WEST SUSSEX COUNTY COUNCIL CONSULTATION

TO:	Mid Sussex District Council - FAO: Stuart Malcolm
FROM:	WSSC – Highways Authority
DATE:	5 February 2026
LOCATION:	Land West Of Kings Business Centre Reeds Lane Sayers Common
SUBJECT:	DM/25/3067 Erection of 80 new residential dwellings (Use Class C3), including affordable housing units, vehicular, pedestrian and cycle access (including new footpath links to the east and west of the site along Reeds Lane), landscaping and open space, parking, sustainable drainage and other related works.
DATE OF SITE VISIT:	16 December 2025
RECOMMENDATION:	More Information

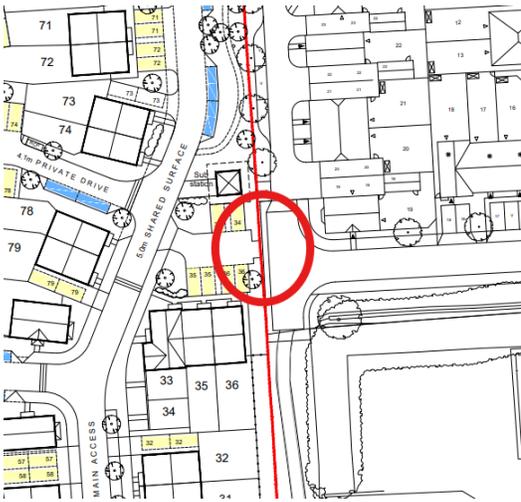
The extension of the 30mph would only be appropriate if the clear visibility distance (CVD) of the terminal signs is able to be adhered to. Based on the 85th percentile speeds, for a 60mph road meeting a proposed 30mph, the CVD would need to be 40m. If the 30mph is deemed the appropriate solution, we would also recommend that the gateway features should be brought forward to match the terminal locations and a suitable amount of vegetation clearance would be required to meet the CVD.

Alternatively a suitable length of 40mph buffer would also be supported, this would provide a consistent user experience, and be aligned with the mean speeds required for a 40mph. The CVD required for 40mph terminals would be 95m.

The applicant should consider the above and clarify whether Road Safety group requirements can be met, in order for the auditor recommendation to be incorporated. The LHA consider that using MfS2 to calculate stopping sight distance is acceptable on basis of built-up area changing and with the 30mph/village gateway potentially being extended to cover the site/ 40mph buffer depending on what the applicant is able to demonstrate.
